#### **INSTRUCTIONAL BULLETIN NO. 13-20**

#### **Regarding Revised Standard Drawings**

**Effective for the February 2014 Letting (December 4 turn-in)**, the following Standard Drawings are revised and Section V of the Design Guidelines is revised for this update.

STANDARD STEEL SIGN SUPPORTS

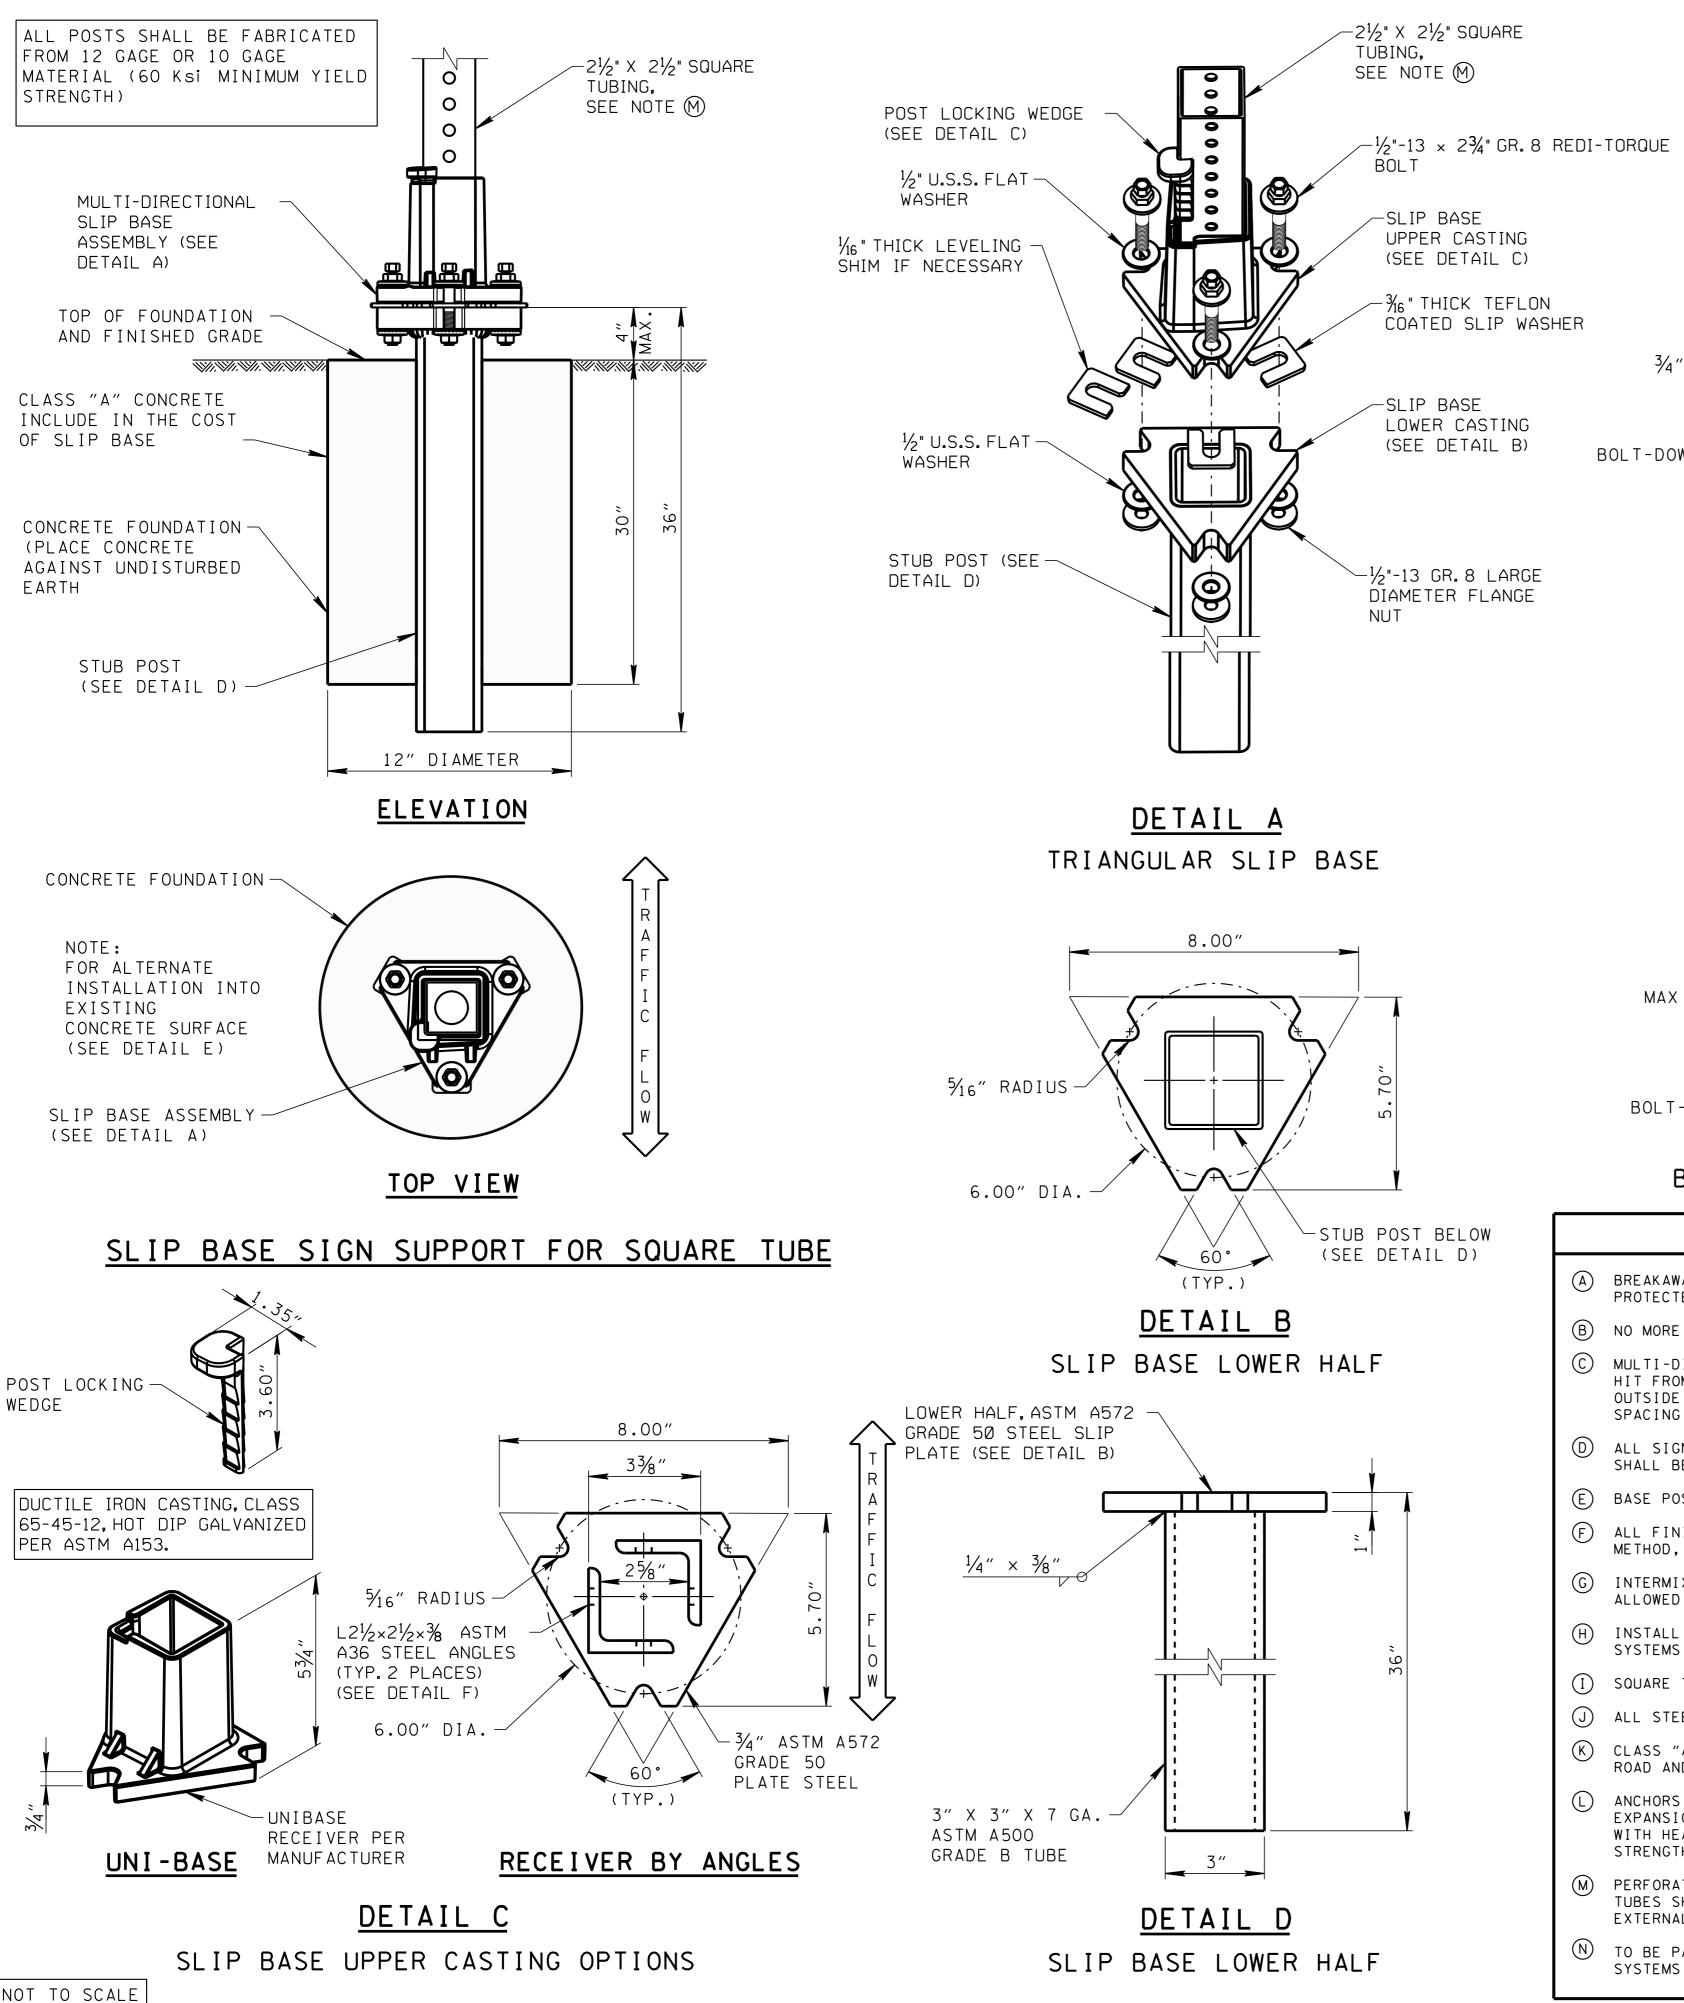
REV. 7-19-13: FY FOR 12 GAUGE P POST CHANGED TO 60 Ksi. ADDED P9 POST REVISED FOOTNOTES. CHANGE TITLE.

FOR 0.105" USS GAGE 12 GAGE;  $F_Y$ =60,000 PSI MIN.

FOR 0.083" USS GAGE 14 GAGE;  $F_{\gamma}$ =60,000 PSI MIN.

MULTI-DIRECTIONAL SLIP BASE BREAKAWAY SQUARE TUBE SIGN SUPPORT

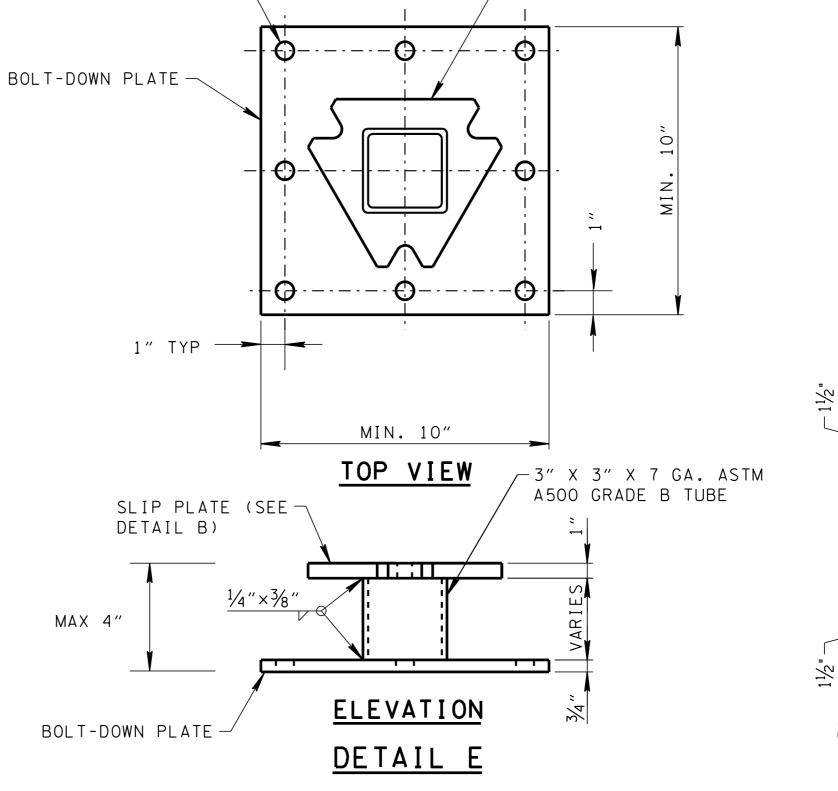
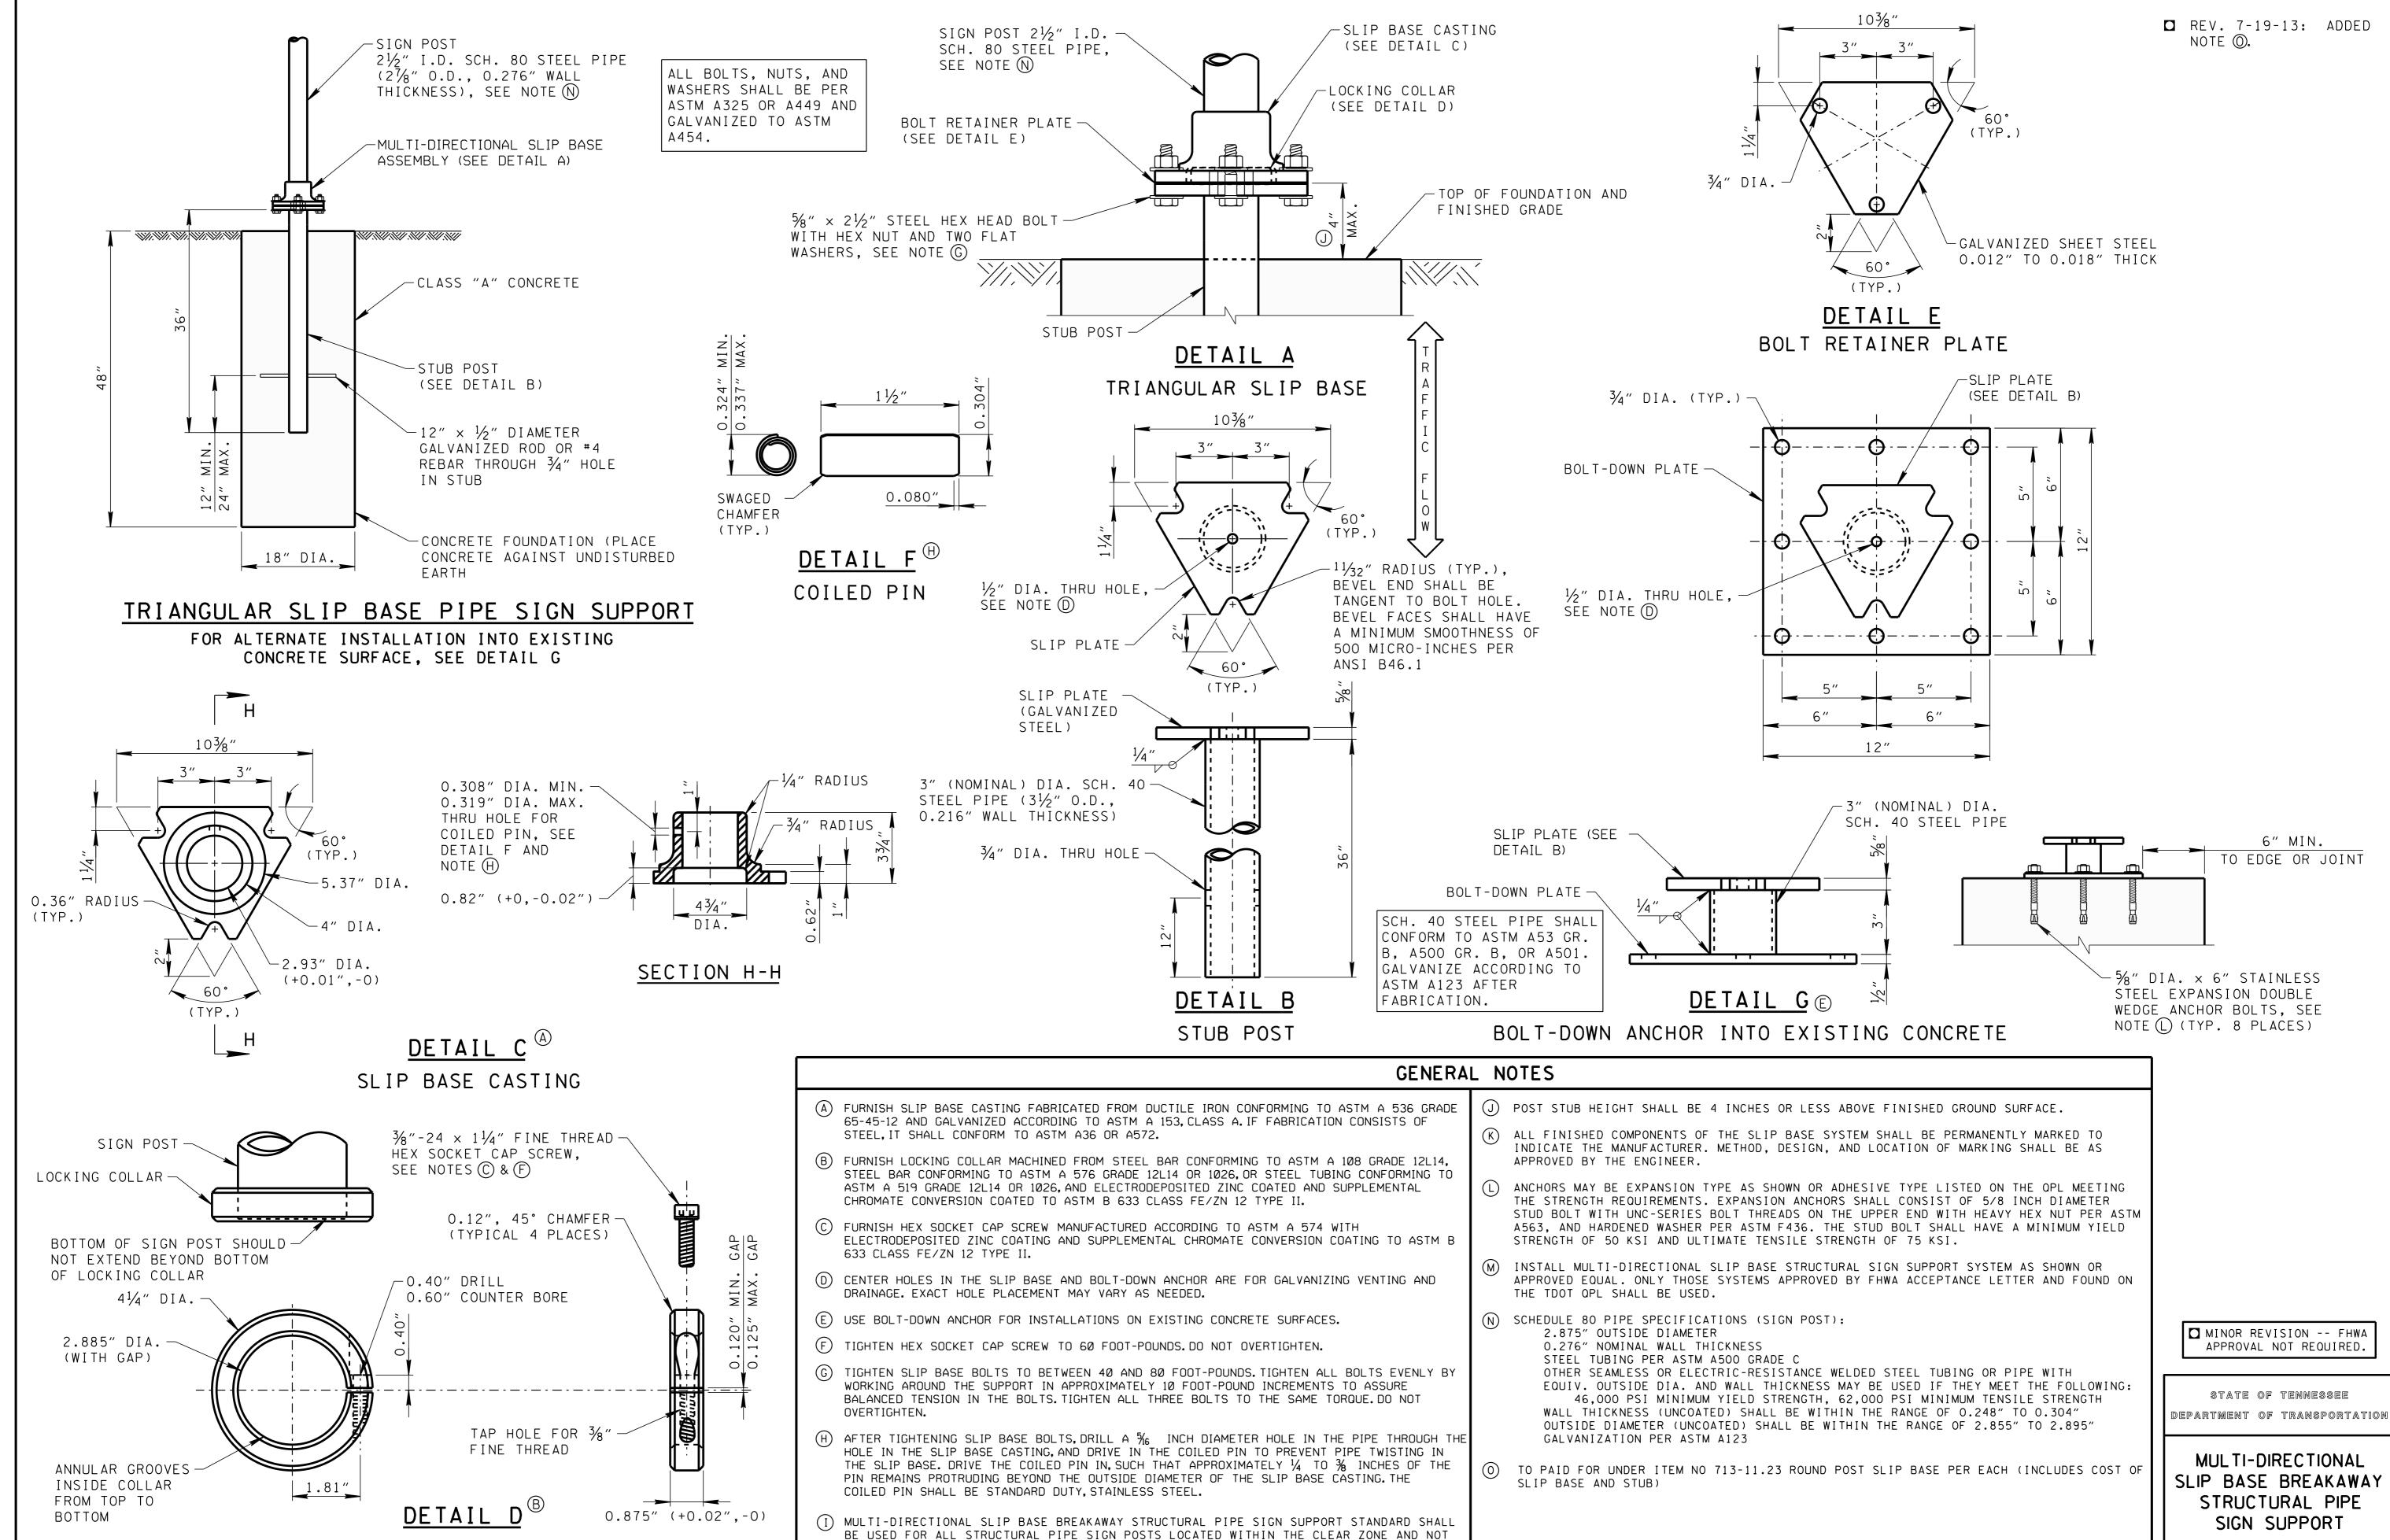
☐ REV. 7-19-13: ADDED

NOTE (M).

NOTE (N). MINOR EDITS

TO DRAWINGS. MODIFIED

- (M) PERFORATED/KNOCKOUT POSTS SHALL BE SQUARE TUBE FORMED 10 OR 12 GUAGES, ASTM A1011 GRADE 50 STEEL. THE SQUARE TUBES SHALL BE WELDED DIRECTLY IN THE CORNER BY HIGH FREQUENCY RESISTANCE WELDING OR EQUAL. THE POSTS SHALL BE EXTERNALLY SCARFED TO AGREE WITH STANDARD CORNER RADII OF \\\frac{1}{3}2 \pm \frac{1}{64} INCHES.

- (N) TO BE PAID FOR UNDER ITEM NO. 713-11.21 P POST SLIP BASE PER EACH (INCLUDES COST OF SLIP BASE AND STUB). SYSTEMS LISTED ON QPL NUMBER 33 MAY BE USED.
